United States Patent and Trademark Office

A POLICA TIONANO	FILING DATE	FIRST NAMED INVENTOR	ATTORNEY DOCKET NO.	CONFIRMATION NO.
APPLICATION NO. 10/750,069	12/31/2003	Lars Severinsson	03384-P0011A	9091
24126 7	7590 01/12/2005		EXAMINER	
ST. ONGE STEWARD JOHNSTON & REENS, LLC 986 BEDFORD STREET STAMFORD, CT 06905-5619			RODRIGUEZ, SAUL	
			ART UNIT	PAPER NUMBER
STAMFORD,	CI 00903-3019	13-3019	3681	
		DATE MAILED: 01/12/2005

DETAILED ACTION

This is a first office action on the merits of patent application S. N. 10/750,069.

Fig. 2

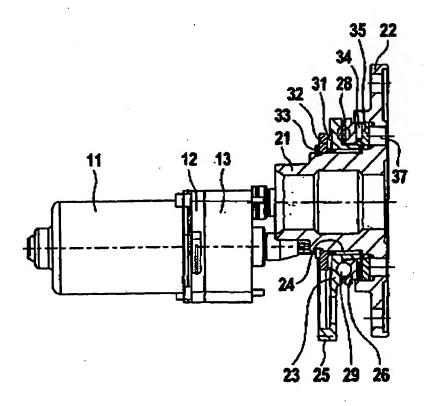
Binkley, however, discloses an actuator mechanism without balls. Nestler et al., on the other hand, discloses a conventional ball ramp actuator (Figs. 2 and 4) having a rotatable shaft (17), and thrust members, balls (29), a circumferential holder (28), and thrust members (23, 26).

Then, it would have been obvious to a person of ordinary skill in the art at the time the invention was made to use a ball ramp mechanism on the device of Binkley in view of Nestler et al. to reduce friction and binding between the components.
